MONTGOMERY COUNTY HISTORIC PRESERVATION COMMISSION
STAFF REPORT

Address:	7319 Willow Ave., Takoma Park	Meeting Date:	9/3/2025
Resource:	Outstanding Resource Takoma Park Historic District	Report Date:	8/27/2025
Applicant:	Alexandru Cojocaru Hannah Meyer, Architect	Public Notice:	8/20/2025
Review:	HAWP	Tax Credit:	No
Case Number:	1128193	Staff:	Dan Bruechert
Proposal:	Fenestration Alteration

Figure 3: 1927 Sanborn Fire Insurance Map showing the rear of the bump-out is nearly co-planer with the historic rear wall.

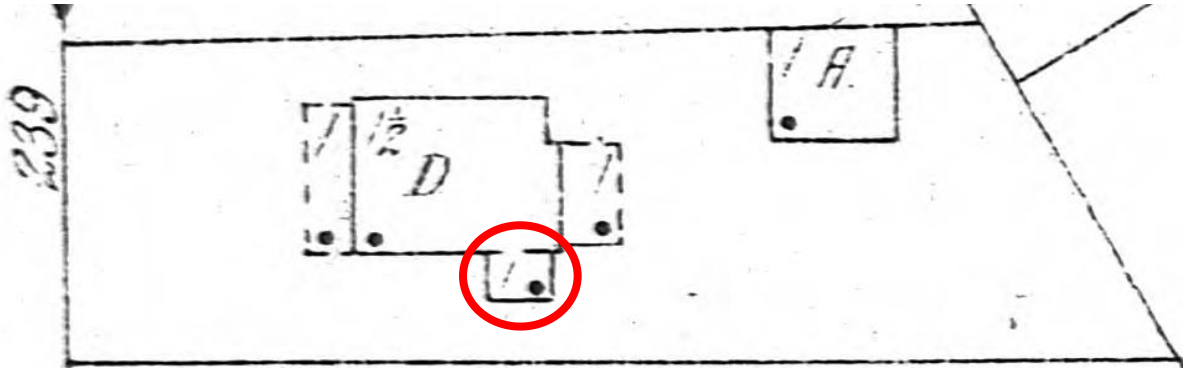
On the right side of the house, there is a single room bump-out with a side entrance that, based on Staff's comparison of the Sanborn Fire Insurance Map with the existing plans, appears to have been extended towards the rear sometime after 1963.

Based on Staff's observations at the site visit, the submitted photographs, and a comparison of the existing site plan to the Sanborn Maps, Staff finds this opening is likely not historic and is instead a late 20th-century alteration.¹ As this feature is not historic, its alteration does not need to comply with *Standard #6* and, as a feature on the rear, Staff finds removing the existing window and enlarging the opening will not have a significant impact on the historic character of the house or surrounding historic

Figure 5: Demolition plan (left), showing the section of wall to be removed; and proposed floor plan showing the paired window (right).

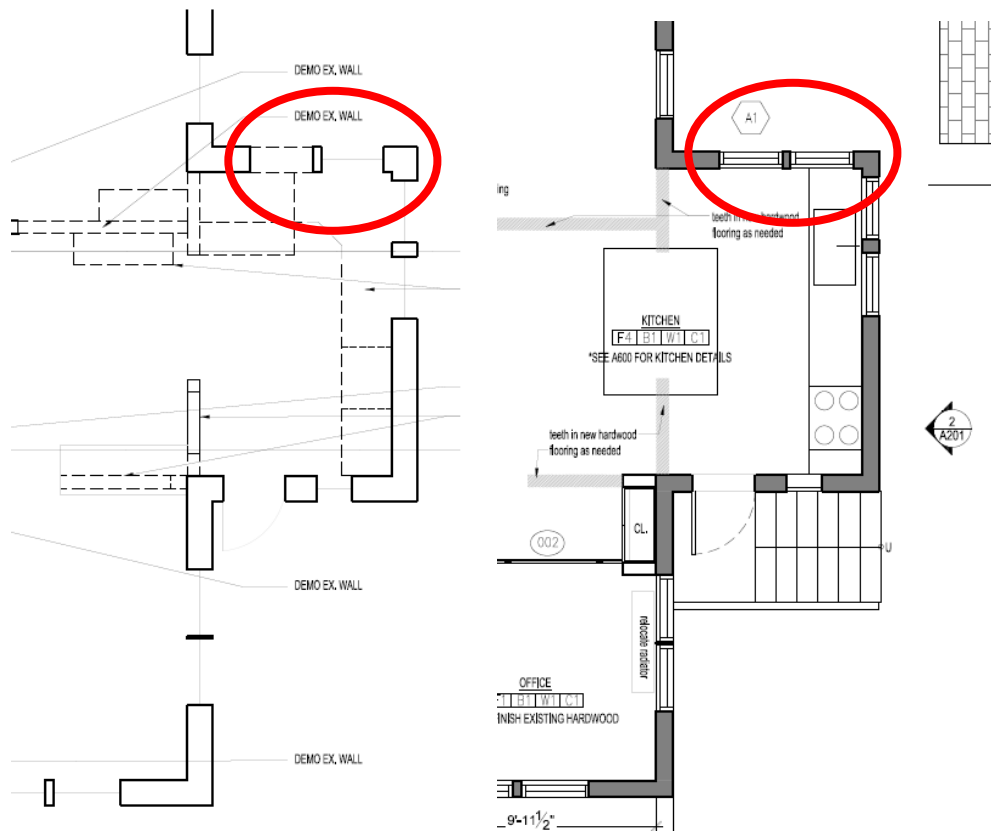
The application narrative states the proposed wood windows will match the adjacent window size, style (one-over-one sash), and material and that the trim will replicate the existing profile and painted finish. Staff finds a window that satisfies these criteria would be appropriate under 24A and the *Standards and Design Guidelines*, but the information provided in the application is not sufficient to verify the proposed window will satisfy these requirements. Staff recommends the HPC add a condition to the approval of this HAWP that requires the applicant to submit measured drawings of the proposed window, including sections of the proposed window. Final approval authority to ensure the window satisfies these criteria can be delegated to Staff. With the recommended condition, Staff finds the window and its associated trim satisfy the requirements of 24A-8(b)(2), the *Design Guidelines*, and *Standard #2*.

1. Measured drawings, including profiles, of the proposed window need to be submitted to Staff before issuing the final HAWP approval documents.
